SOUTH HIGH SCHOOL SECOND ADDITION TO WICHITA, SEDGWICK COUNTY, KANSAS

RE: SUB 2003-90 - One-Step Final Plat of South High School Second Addition

CASE NUMBER: SUB 2003-90 -- SOUTH HIGH SCHOOL SECOND ADDITION

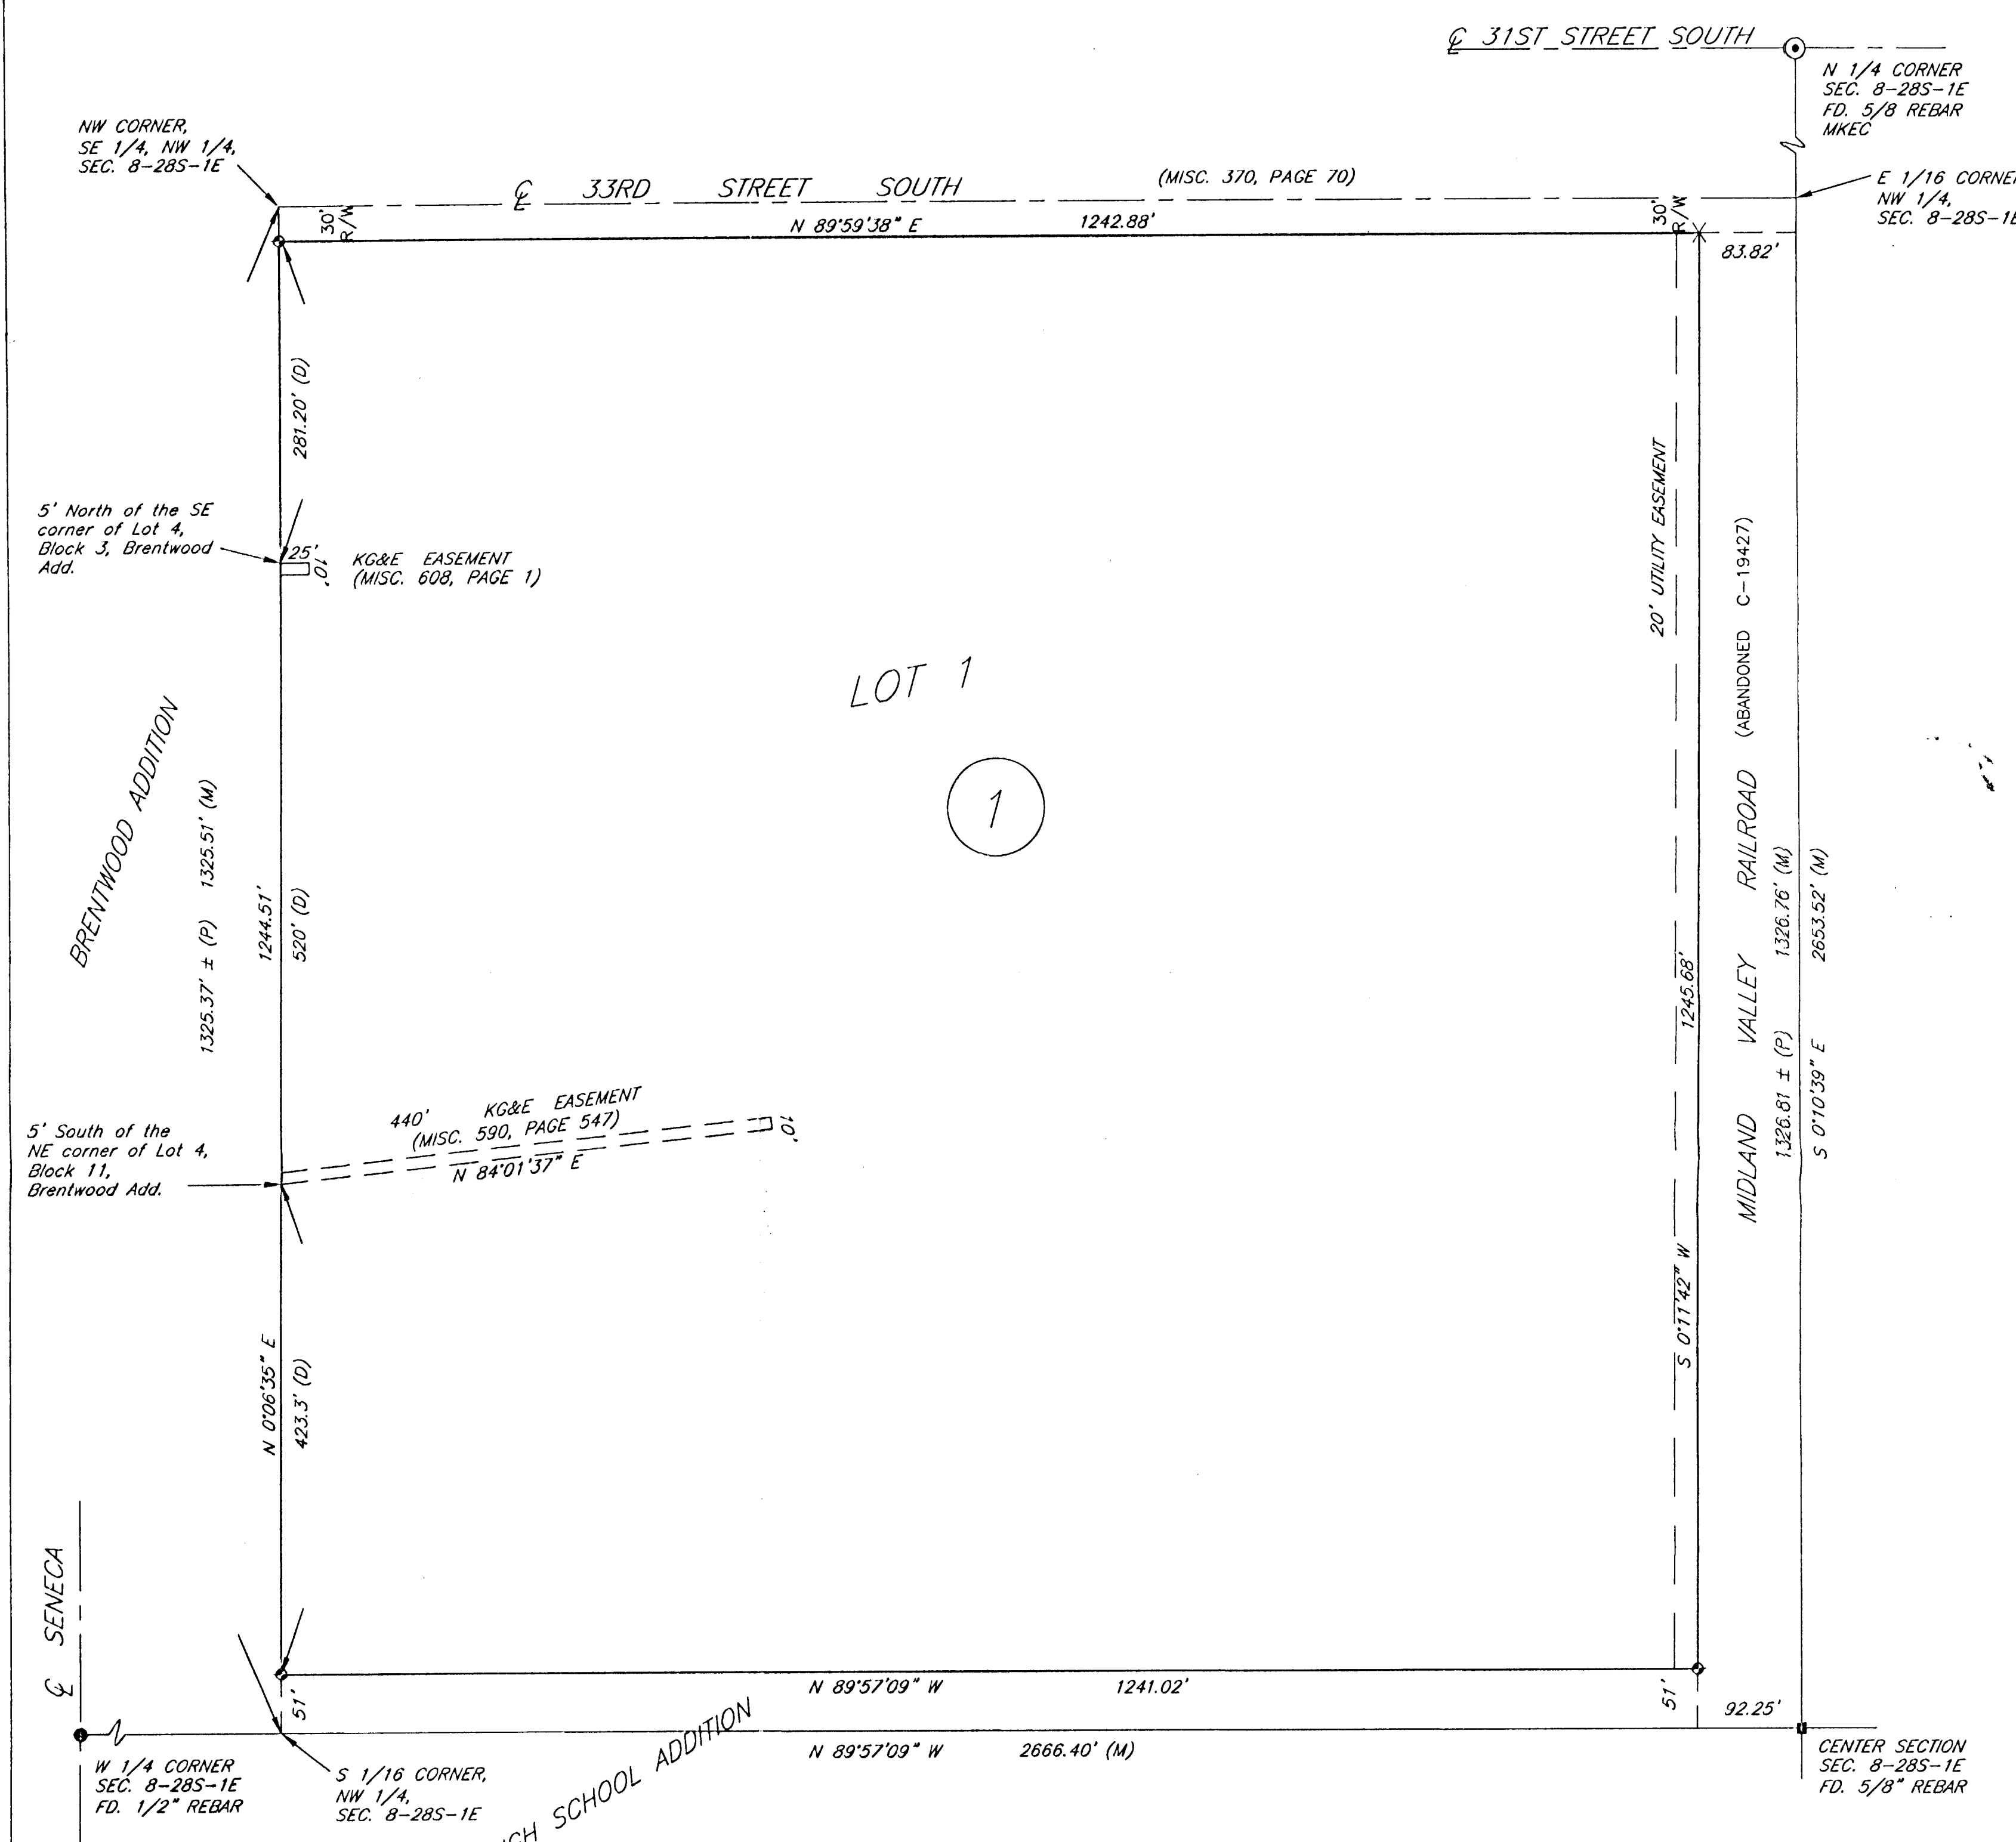
- A. Municipal services are available to serve the site. City Engineering needs to comment on the need for guarantees or easements. City Water and Sewer Department has requested a 20-ft easement along the east line of the plat for future water line improvements.

- C. City Engineering needs to comment on the status of the applicant's drainage plan.
- D. County Surveying advises that the bench mark needs an elevation.

- E. County Surveying requests a dimension of the width of the south end of railroad right-of-way.
- F. The SW, NW and NE corners of the SE 1/4 of the NW 1/4 need labels.

- G. County Surveying advises that the KG&E easements must be shown with sufficient ties to locate them definitely with respect to the subdivision.
- H. The centerline of 33rd St. South should be denoted.

- I. The dimension denoted for the west property line needs to be corrected.
- J. The 40-ft utility easement along the south line of the plat is located in the adjoining plat and may be deleted from the final plat tracing.

- M. The MAPC signature block needs to be revised to reference "John L. Schlegel, Secretary".
- N. The Applicant is reminded that a platting binder is required with the final plat. Approval of this plat will be subject to submittal of this binder and any relevant conditions found by such a review.

- O. The plat title should reference "Wichita, Sedgwick County, Kansas".
- P. *The platlor's text shall include language that a drainage plan has been developed for the plat and that all drainage easements, rights-of-way, or reserves shall remain at established grades or as modified with the approval of the applicable City or County Engineer, and unobstructed to allow for the conveyance of stormwater.*
